<h1>CHANGE ORDER</h1>	CHANGE ORDER NUMBER
		6
		12/16/2024
		Page 1 of 6

<input checked="" type="checkbox"/> ORDERED BY ENGINEER UNDER SECTION 1-04.4 OF THE STANDARD SPECIFICATIONS. <input type="checkbox"/> CHANGE PROPOSED BY CONTRACTOR	PROJECT IDENTIFICATION PROJECT NAME: 36 th Avenue W & 35 th Avenue W, 164 th St SW to SR 99 PROJECT NUMBER: RC1783, RC1784, RR6337, RR6342, UPI 06-0014 Fed Aid #: STBGUL-2585(001)
CONTRACTOR ENDORSEMENT:	CONTRACTOR: Marshbank Construction, Inc.
<div style="display: flex; justify-content: space-between;"> <div>SIGNATURE</div> <div>DATE</div> </div>	ADDRESS: PO Box 97 3304 Old Hartford Rd Lake Stevens, WA 98258
<div style="text-align: center;">TITLE</div>

This change order compensates the Contractor for added costs associated with shifting the water main to the east as shown on revised attached AWWD plan sheets AW05, AW06, AW07, and AW13 with revisions dated 9/19/24.

REFERENCE
SHEET NO.
AW06

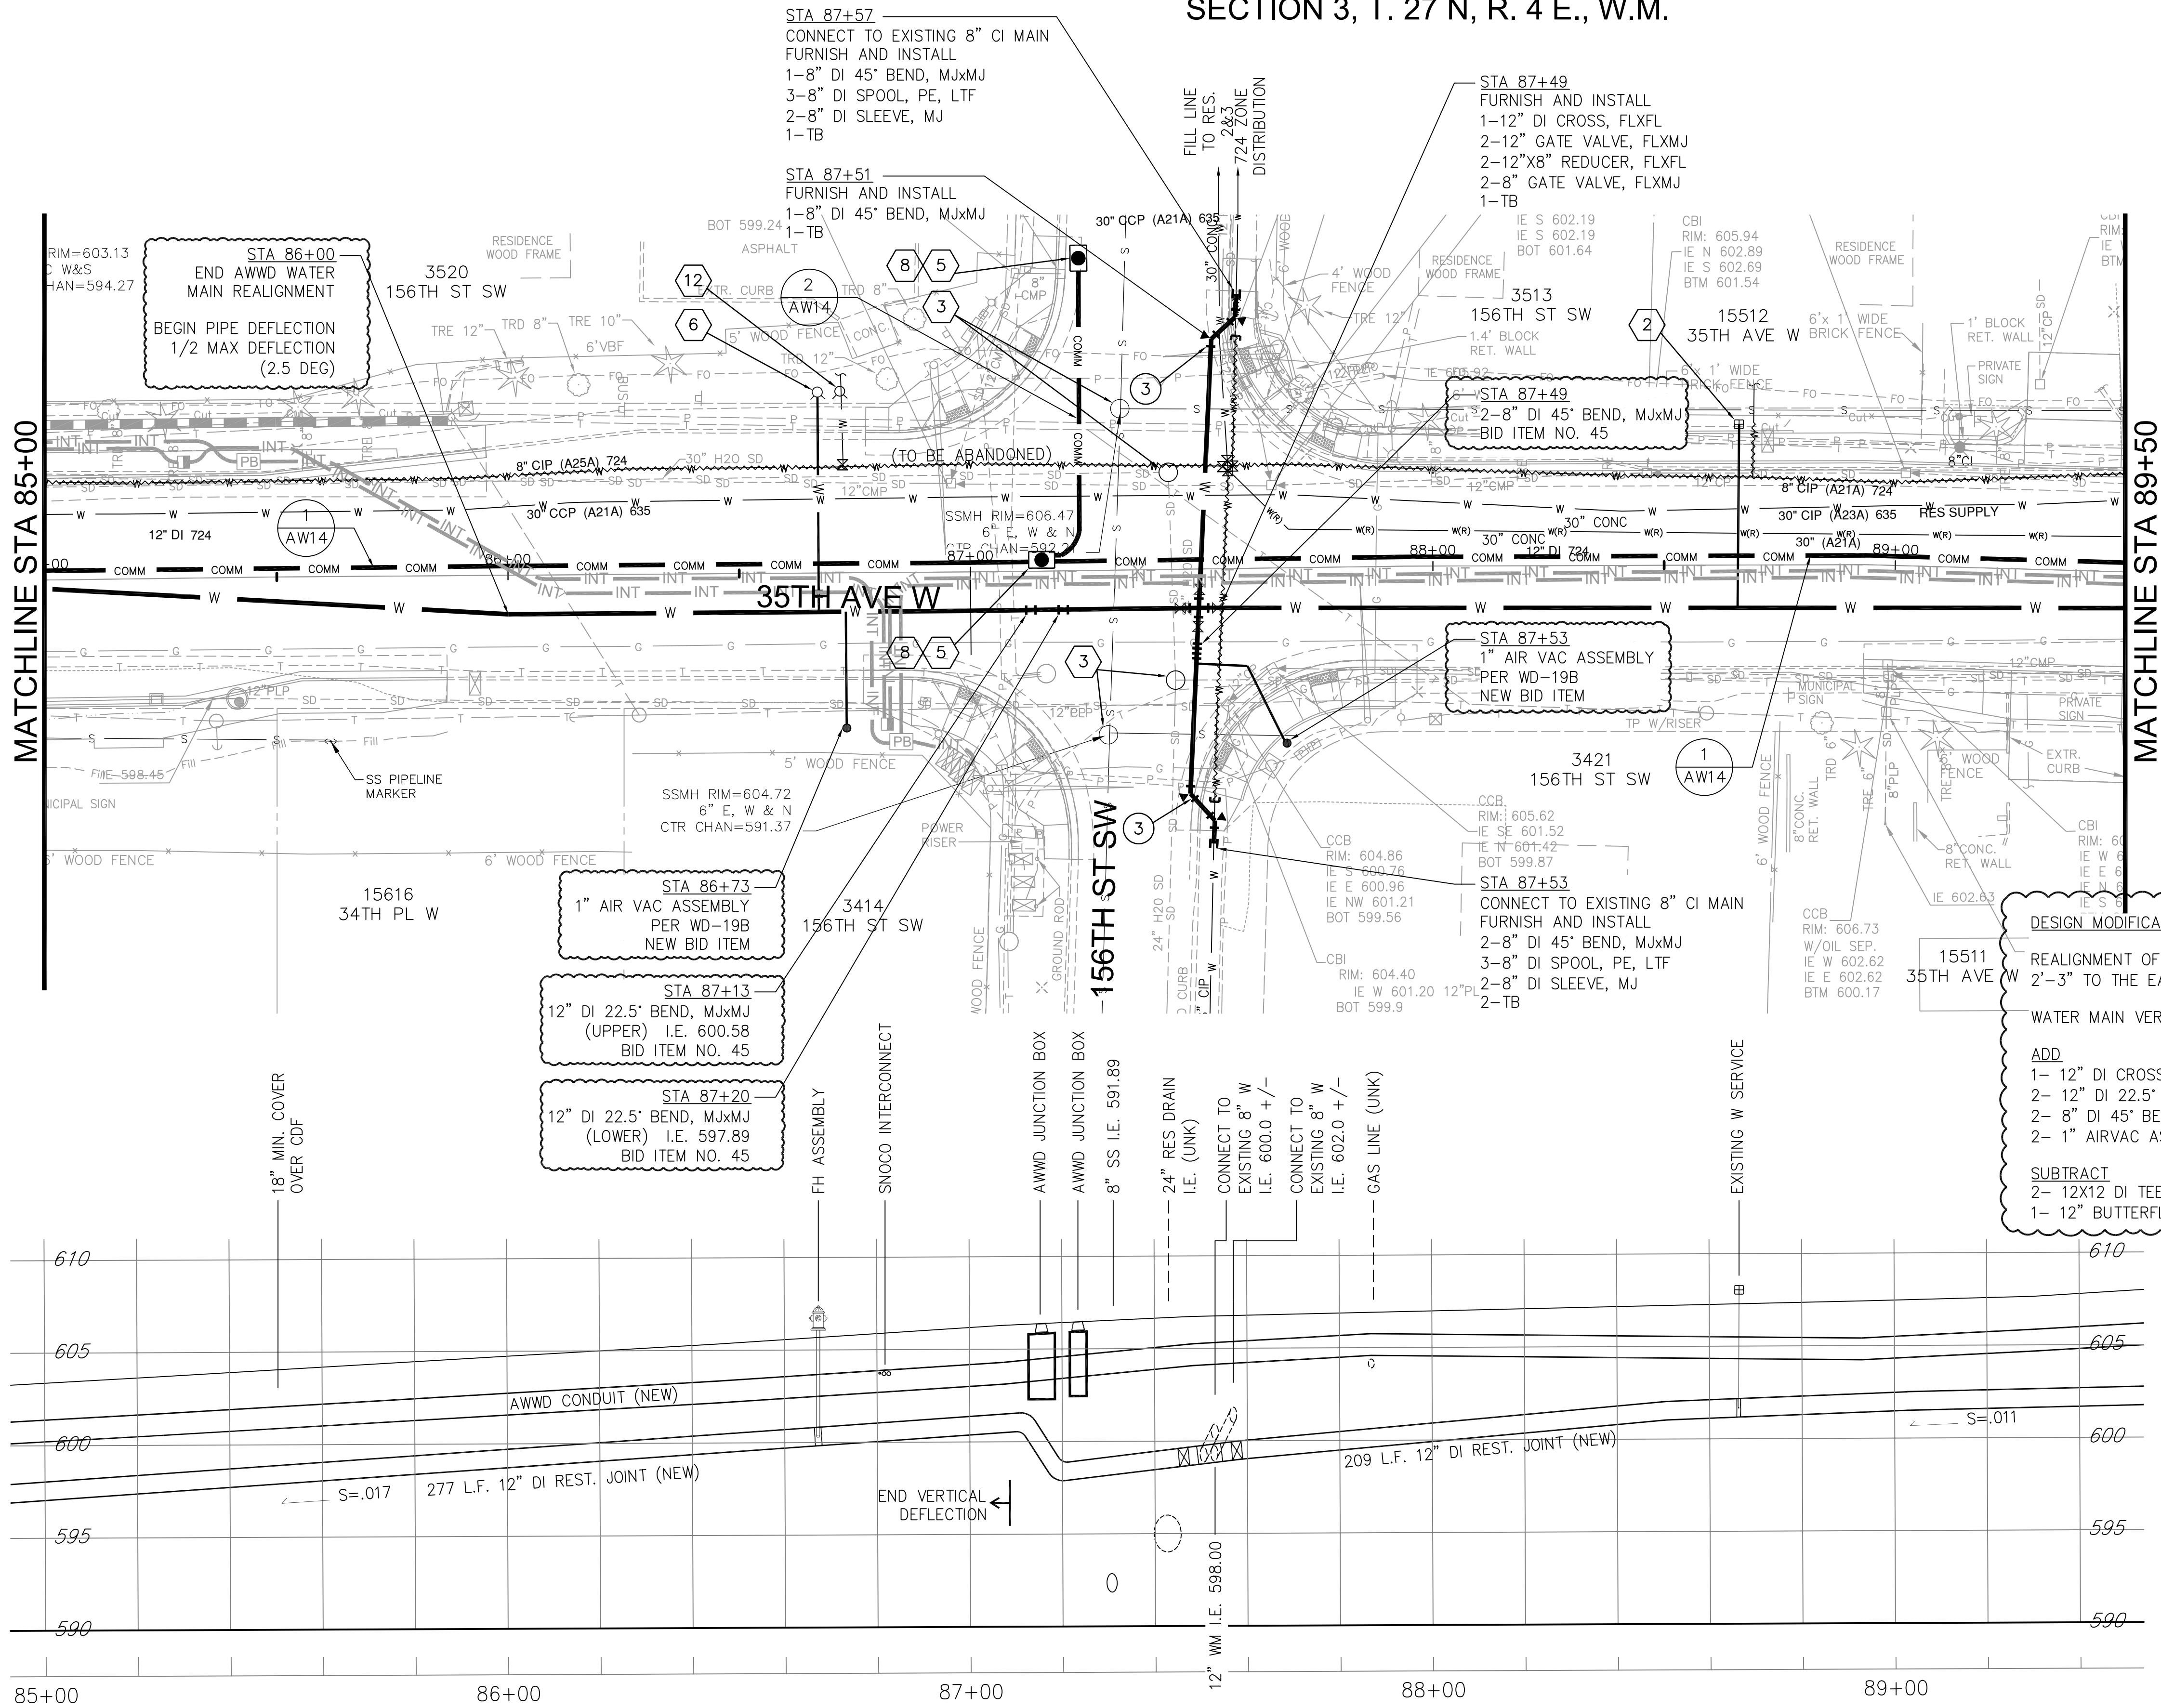
DESIGN MODIFICATIONS ON THIS SHEET:
REALIGNMENT OF WATER AND COMM 2'-3" TO THE EAST
WATER MAIN VERTICAL REALIGNMENT

1
AW13
ENLARGED SITE PLAN

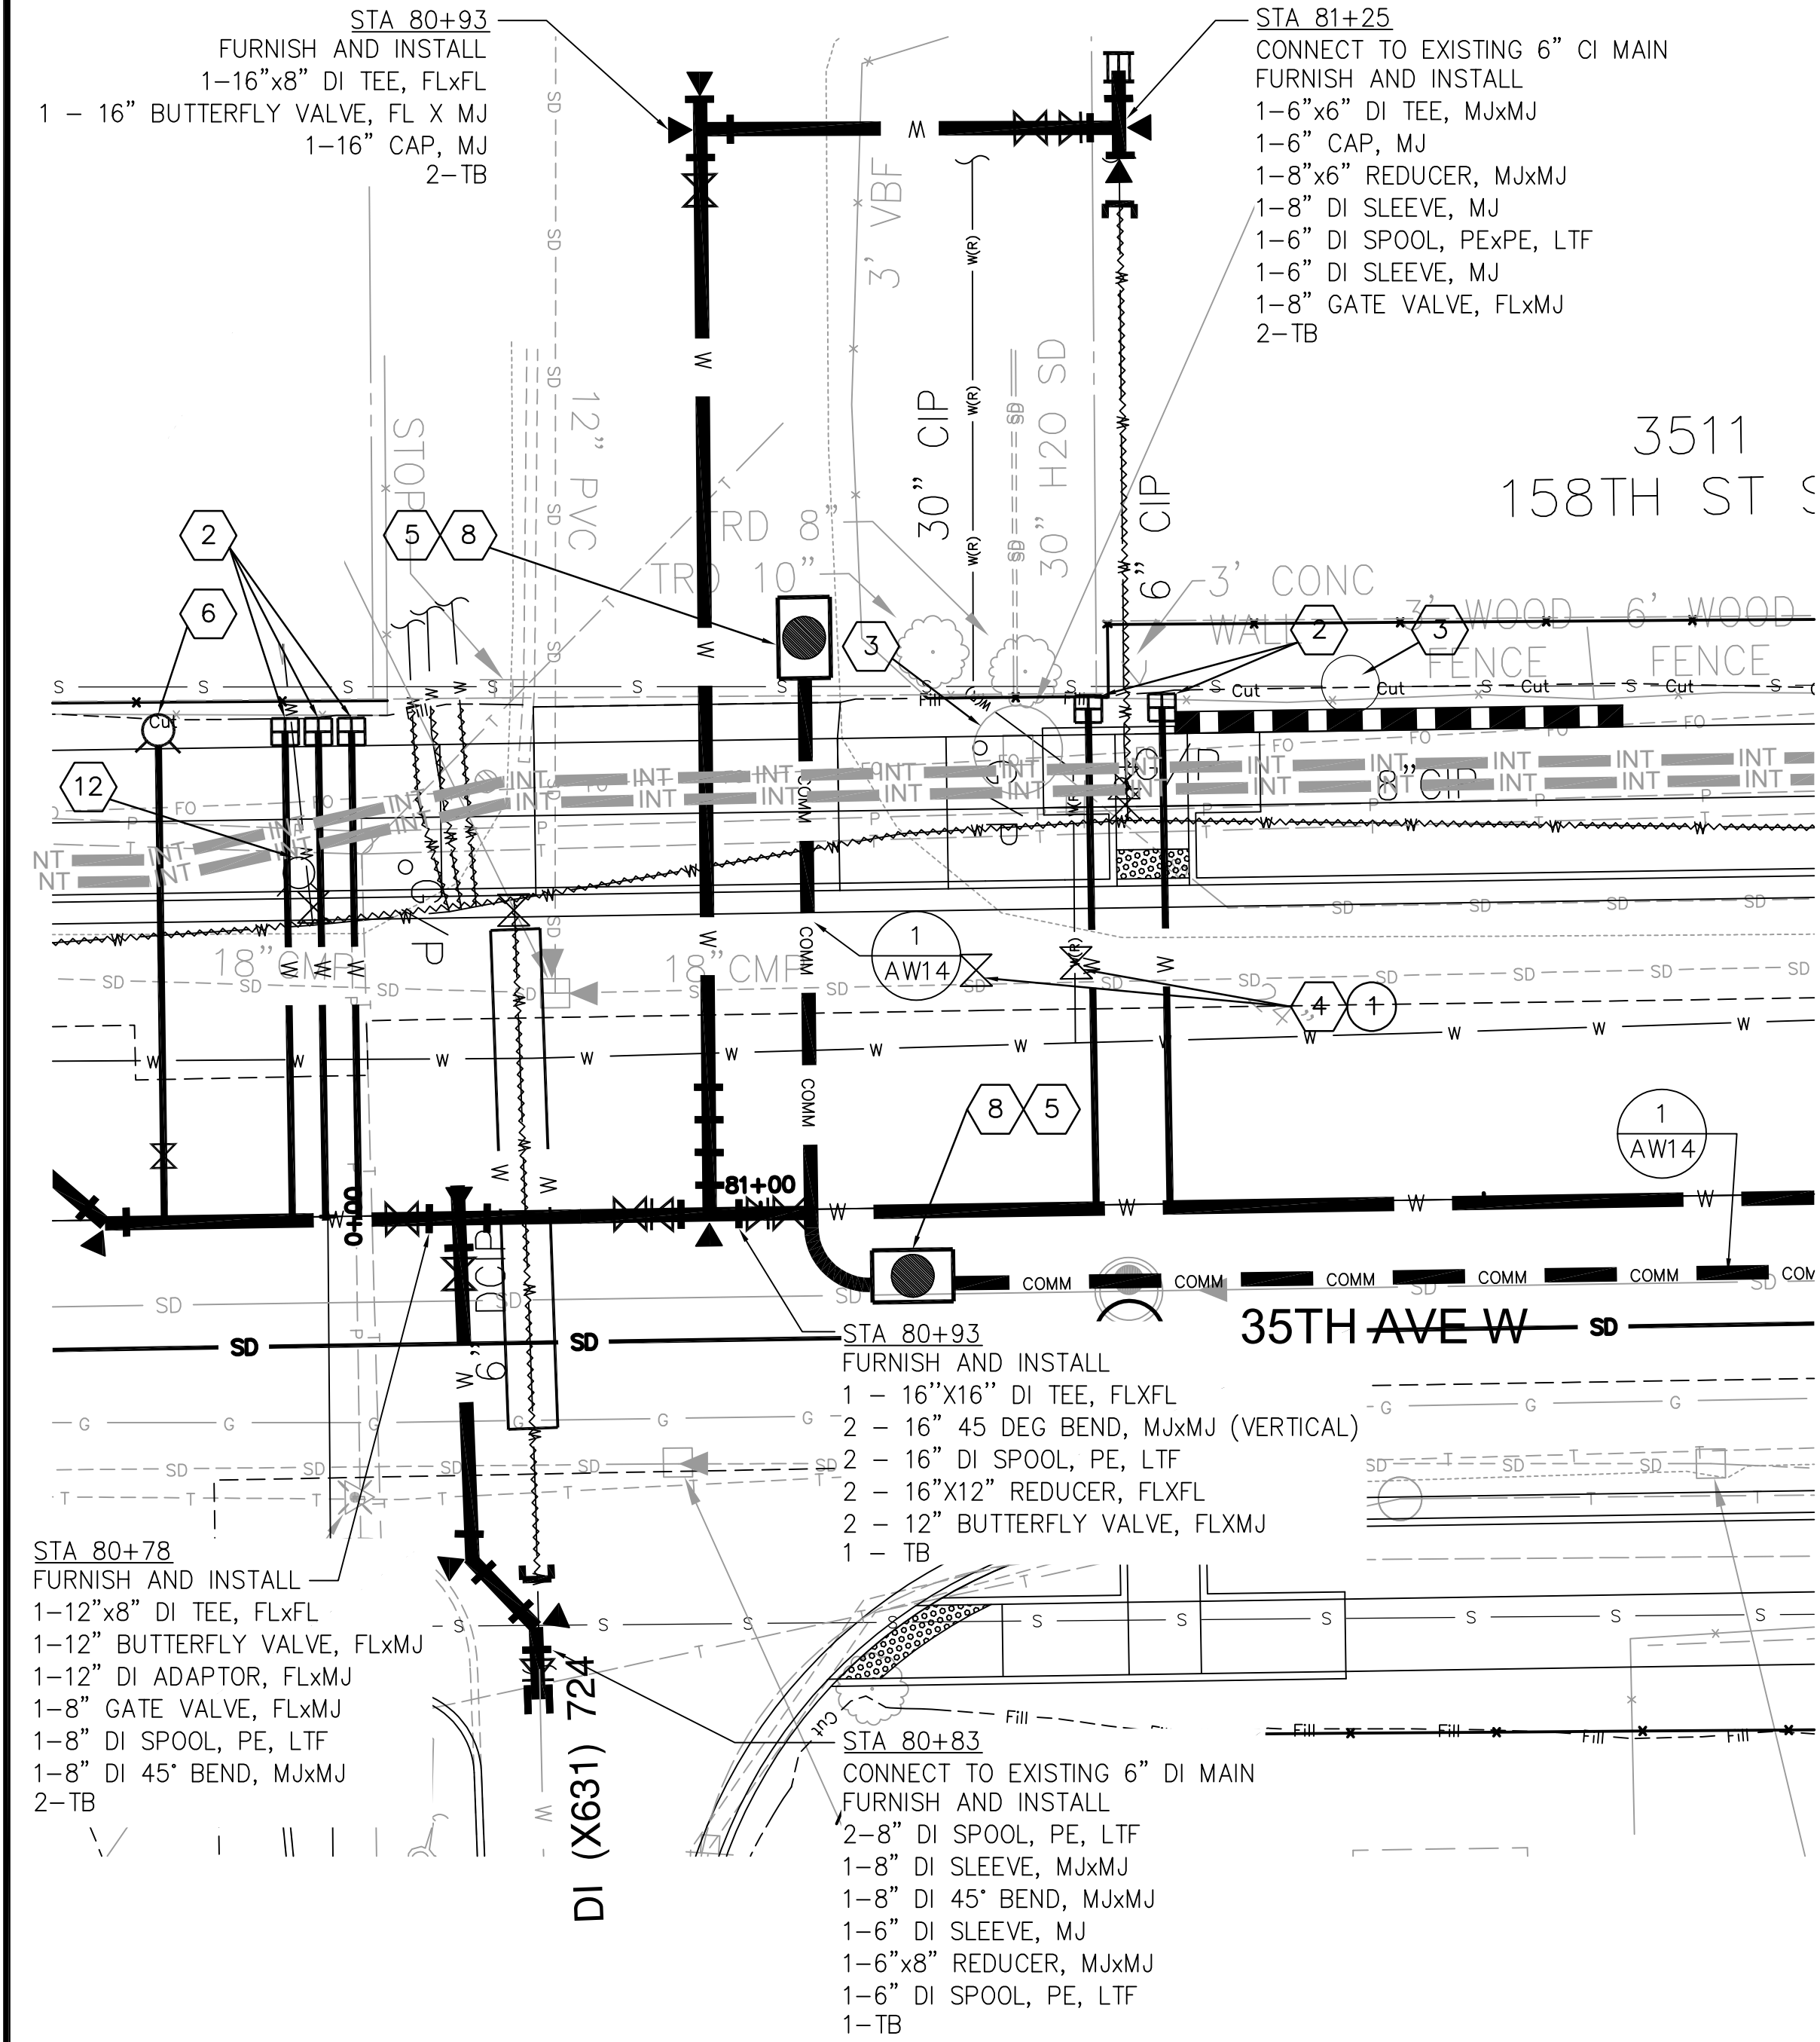
8/07/24	1	TRIPLE CONDUIT / MODIFY INJECTION VAULT	BJG	LCM
9/19/24	2	WATER / COMM CONDUIT REALIGNMENT	BJG	LCM
Change Order #6 12/16/24 Page 6 of 6				
DATE	NO.	REVISION	BY
